**Eastern Corridor Segments II and III
Red Bank Corridor to I-275/SR 32 Interchange (PID 86462)
Public Open House
Meeting Summary Report**

**October 24 and 25, 2018 Public Open House
MEETING SUMMARY REPORT**

**October 24 and 25, 2018 Public Open House
CONCEPT EVALUATION and COMMENT SUMMARY**

New Access Road From SR 32 to Broadwell Through Lakes to Broadwell Road

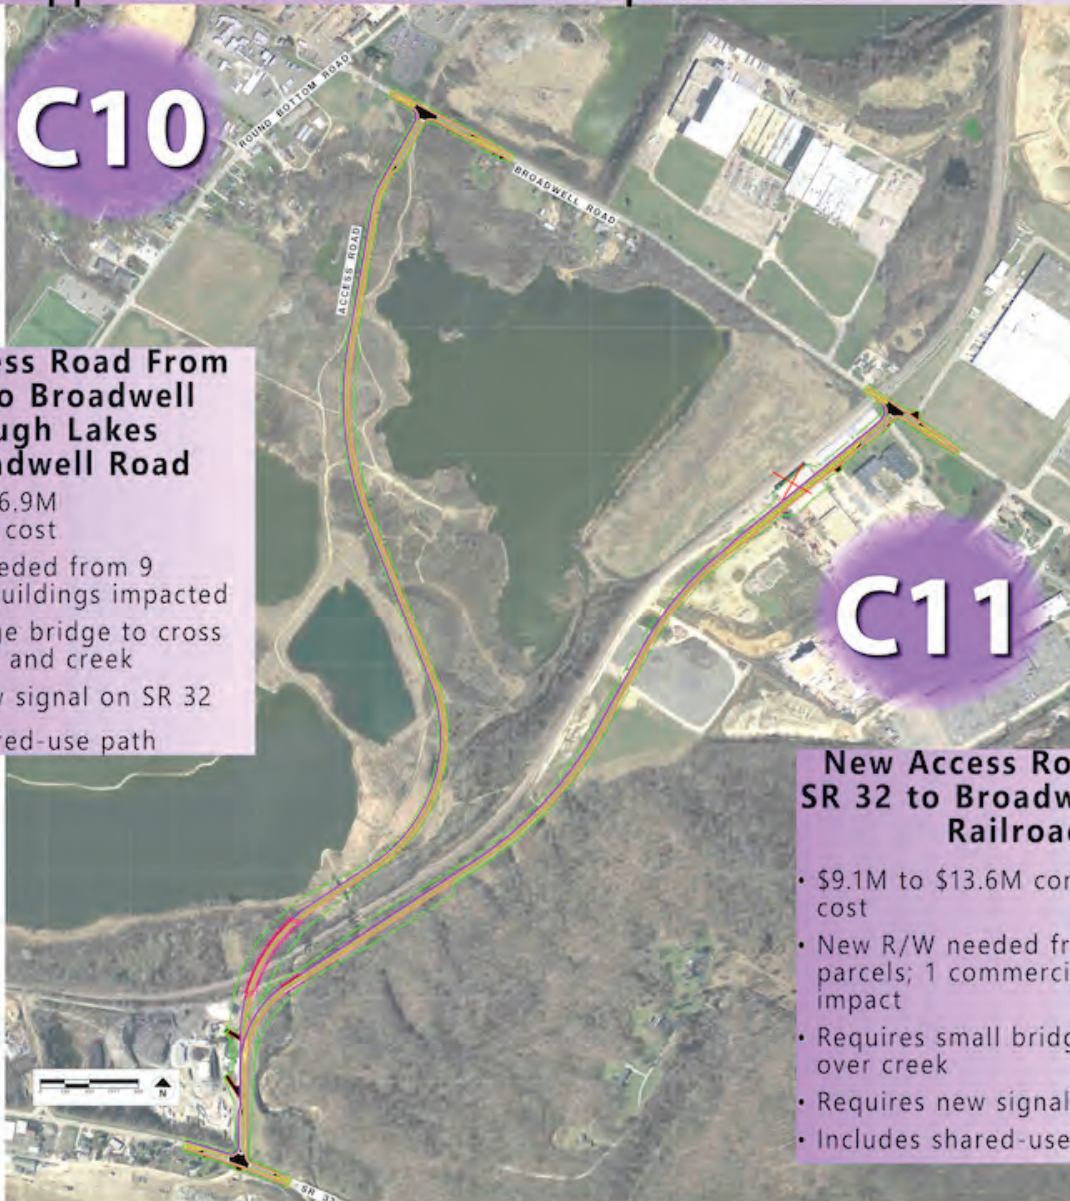
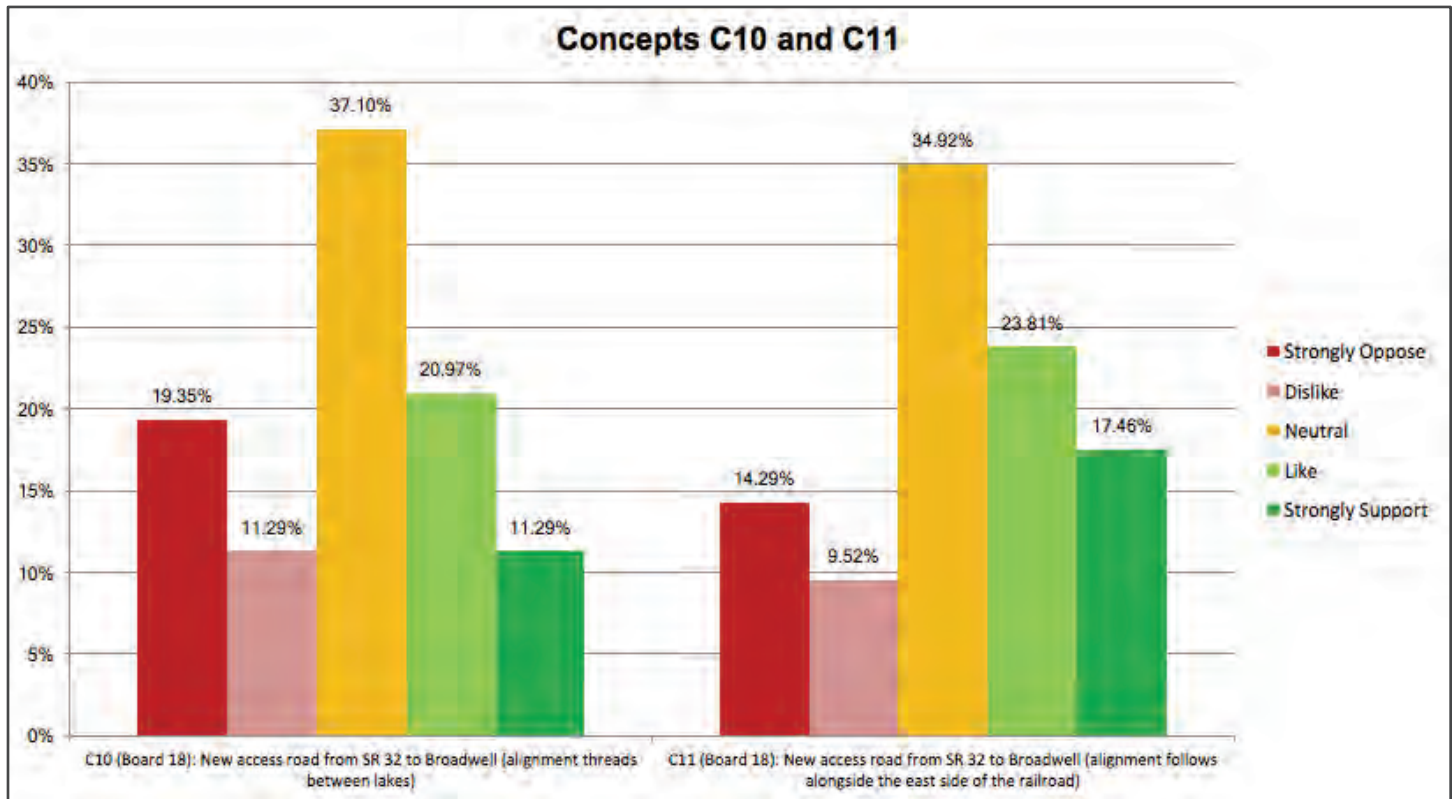
NO.	COMMENT	RESPONSE
1	I would be more interested in C10 & 11 if the mining and landscaping companies would offset the majority of the cost. At this point freight doesn't seem to be a huge problem but this could change if additional mining is planned.	Thank you for your comments. Your input is appreciated and will be taken into consideration as we evaluate the options and develop our recommendations.
2	Like trails on C10 AND C11	Thank you for your comment. Your input is appreciated and will be taken into consideration as we evaluate the options and develop our recommendations.

Continuous Right Turn Lane From SR 125 to Wooster

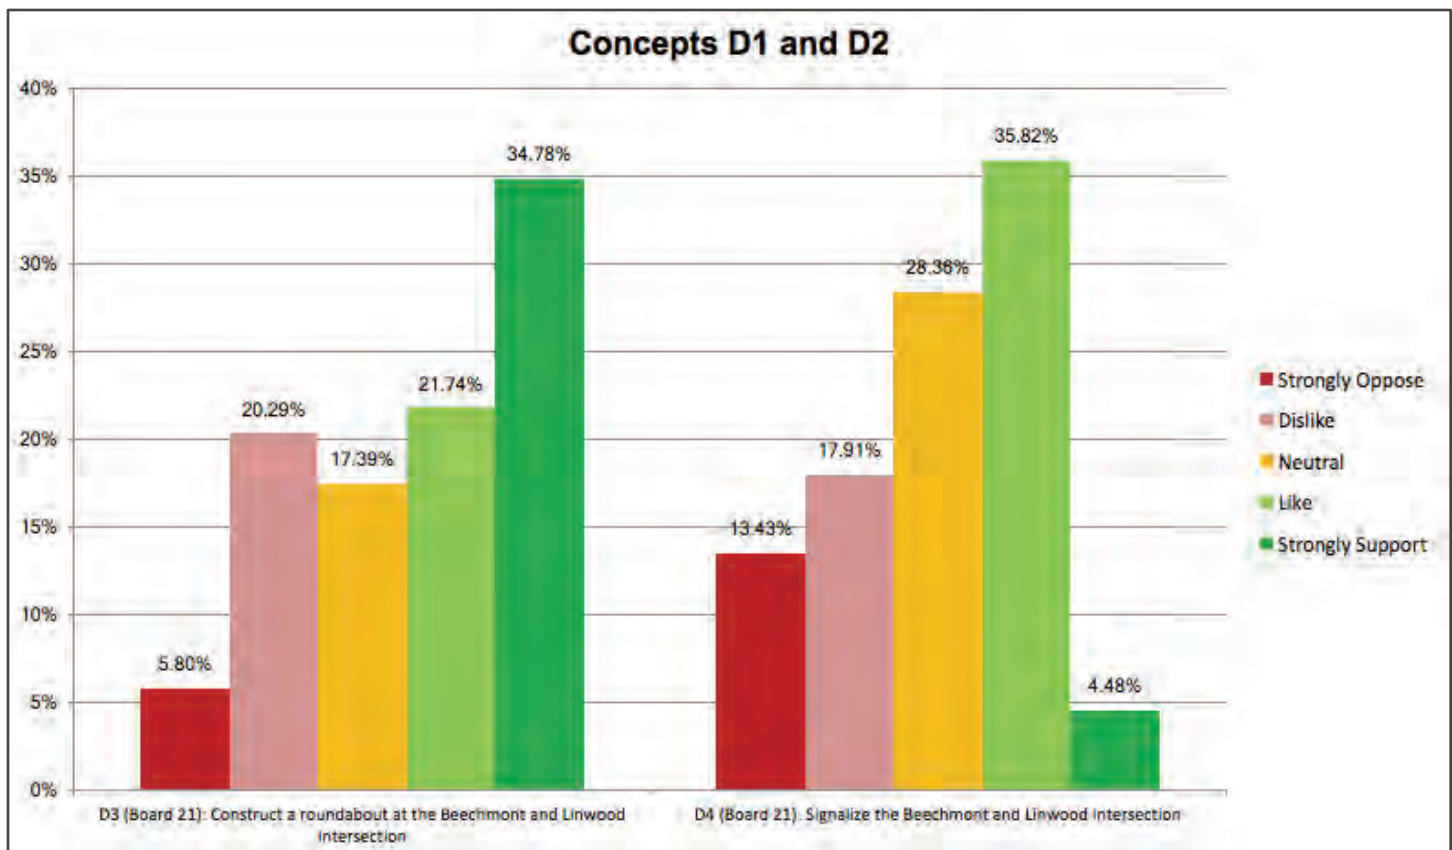
NO.	COMMENT	RESPONSE
1	Option D1 is terrible - continuous right turns promote increased speed, and will only minimally improve travel times at the cost of vastly decreased pedestrian and cyclist safety.	Thank you for your comments. Your input is appreciated and will be taken into consideration as we evaluate the options and develop our recommendations.
2	Regarding D1 - not needed; the traffic is manageable as is.	Thank you for your comments. Your input is appreciated and will be taken into consideration as we evaluate the options and develop our recommendations.

NO.	COMMENT	RESPONSE
1	D2 - amount of usage?	Thank you for your comments. This concept would be an additional connection that would link to concept E5 which connects Wasson to Armleder and could also connect the eastern avenue community to Armleder Park. However, a projection of the number of anticipated users has not yet been developed.
2	I think that there needs to be a focus on providing a safe way for bicycles to travel on Wooster Road and D2 comes way too far down the road to actually accomplish that. It is nice that it provides a cut across to Eastern Ave, but I'm not sure what that would help since it doesn't start until way down the road by the US Bank facility.	<p>Thank you for your comments. Your input is appreciated and will be taken into consideration as we evaluate the options and develop our recommendations.</p> <p>Based on public comment and Advisory Committee discussions, it has been noted that Concept D2 by itself does not adequately meet the needs due to its location in relation to where the potential users are. Therefore, this concept will be considered as a connection in conjunction with Concept E5, which brings Wasson Way to Armleder along US 50.</p>

3	On D2 Board 20, it's essential to get riders from Eastern to Armleder so we don't have bikers on Columbia Parkway - that's dangerous to them and to cars.	Thank you for your comments. Your input is appreciated and will be taken into consideration as we evaluate the options and develop our recommendations.
4	Regarding D2 - please see comments about shared-use paths on page 3 <i>[Respondent shared a general comment about all of the shared-use path options: while I am not opposed to adding these at some point, there is a much greater need to alleviate the vehicle traffic and those issues need to be addressed first].</i>	Thank you for your comments. Your input is appreciated and will be taken into consideration as we evaluate the options and develop our recommendations.

US 50/RED BANK INTERCHANGE FOCUS AREA CONCEPTS E3 and E4, BOARD 25

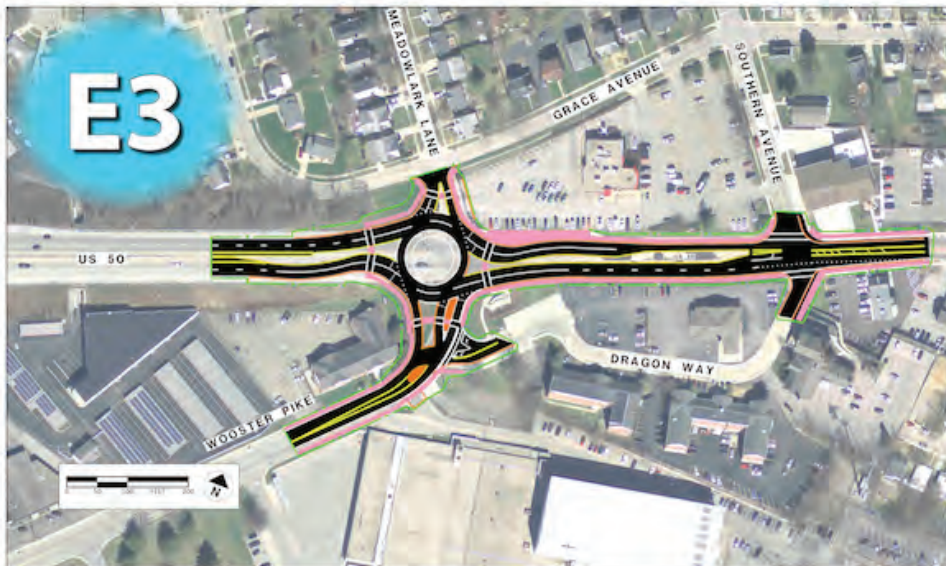
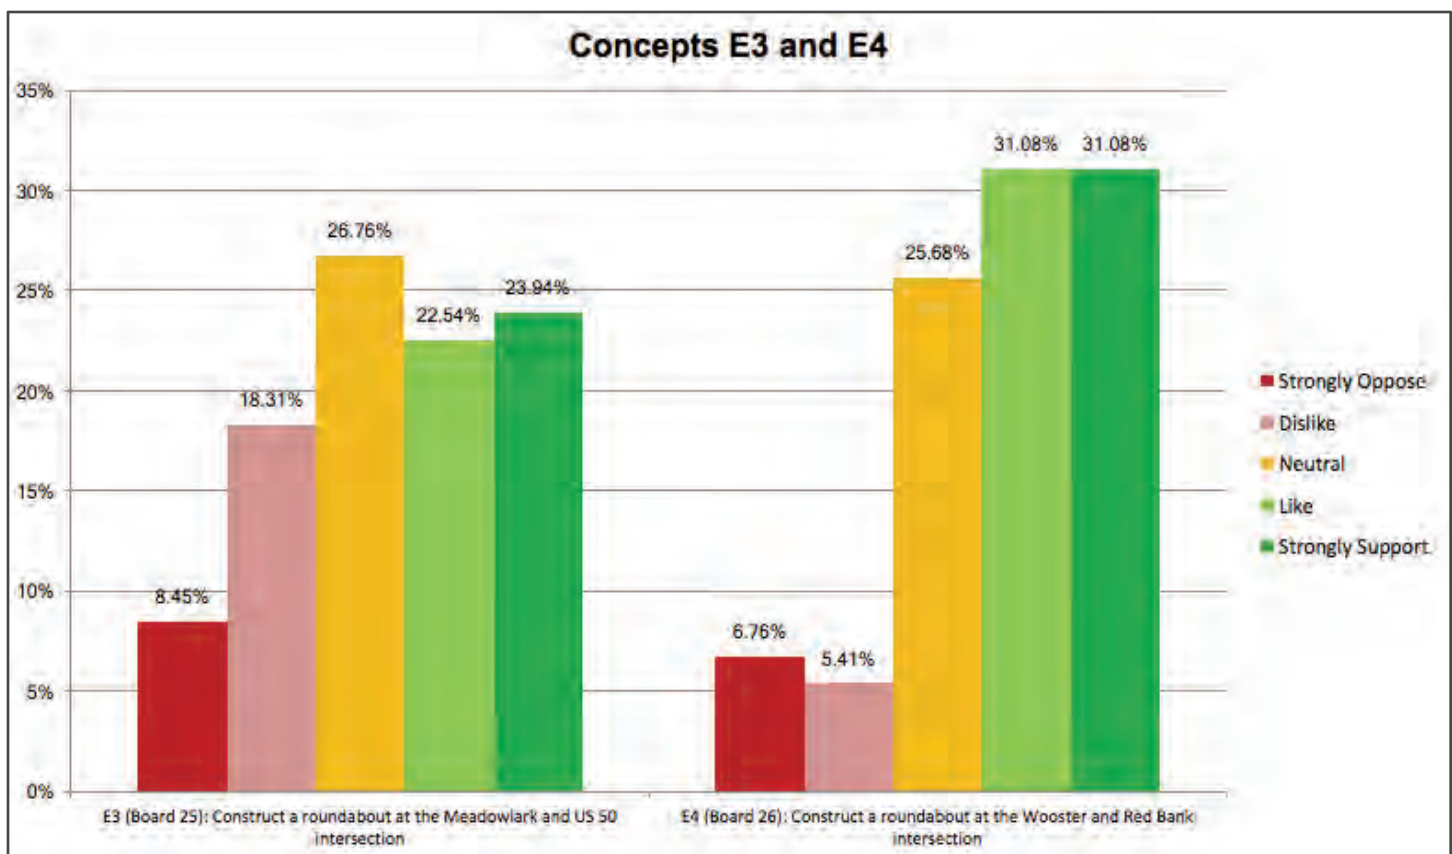
NO.	COMMENT	RESPONSE
1	E4 - if it improves visibility coming from Red Bank	Thank you for your comment. Your input is appreciated and will be taken into consideration as we evaluate the options and develop our recommendations.
2	E4 doesn't seem to accomplish anything despite costing time/money to construct.	Thank you for your comment. Your input is appreciated and will be taken into consideration as we evaluate the options and develop our recommendations.
